From: [Austin Griesbach](#)
To: [Transportation Commission](#)
Subject: Lots to Say, Mostly Want Safer Crossings
Date: Tuesday, March 3, 2026 1:44:39 PM

I am writing regarding Agenda Item 3, file [92139: Public Works Transportation Projects - Regent St.](#) I sincerely appreciate the sidewalk space that has been allocated to pedestrians in the updated design. But I have serious concerns about the safety of the street's new design for vulnerable road users, and concerns with the design's level of compliance with [Complete Green Streets \(CGS\) guidance](#).

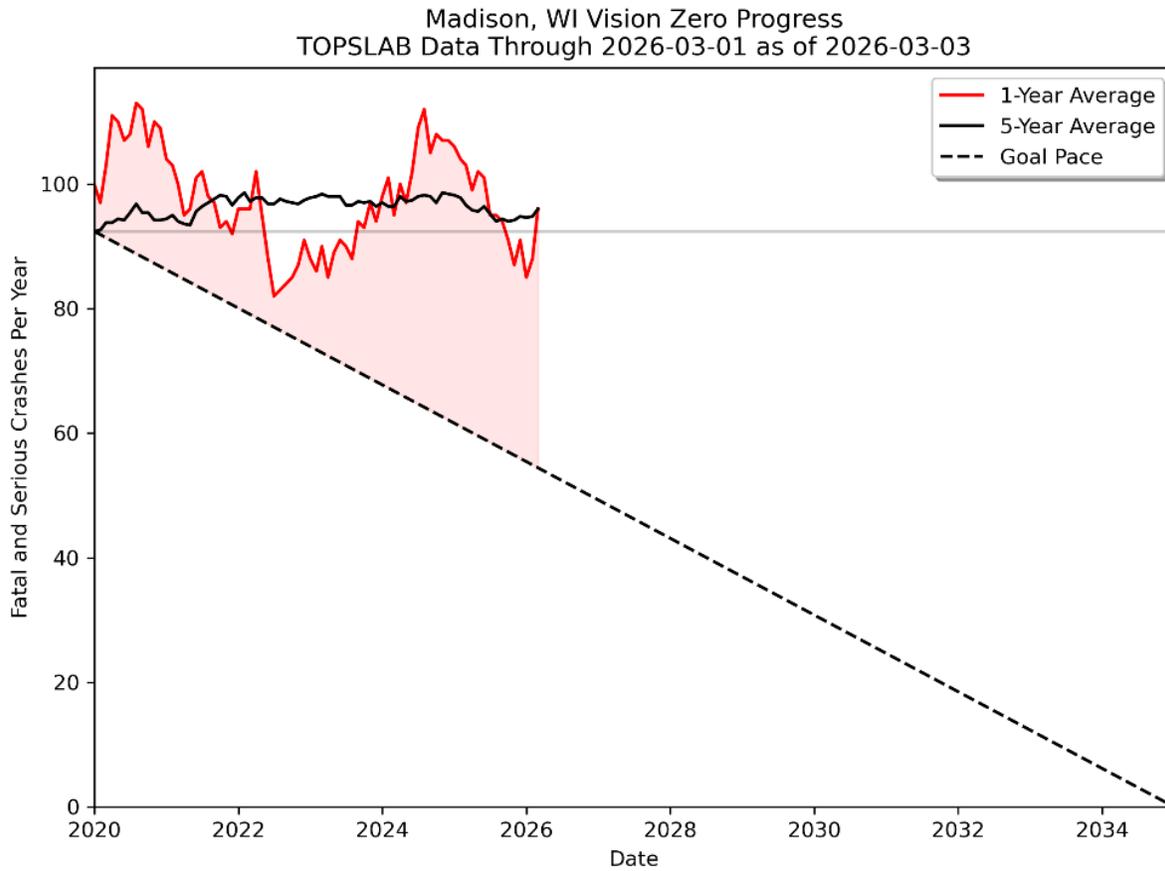
In previous designs the cross-streets also had curb extensions or neck-downs to slow traffic and narrow the East/West crossings for pedestrians. In the new design those have been removed in favor of nice wide turn radii to allow drivers to comfortably speed through at worst, or sit on the crosswalk while waiting to turn at best. I would very much like the curb extensions back, at least on **every** unsignaled cross-street (though I think they're also appropriate on controlled intersections and on Regent itself). And in the case of one-way streets like Orchard, I think it's appropriate to give the curb a 90 degree square profile instead of a smooth radius so a driver couldn't turn incorrectly down the one-way even if they wanted to, let alone unintentionally.
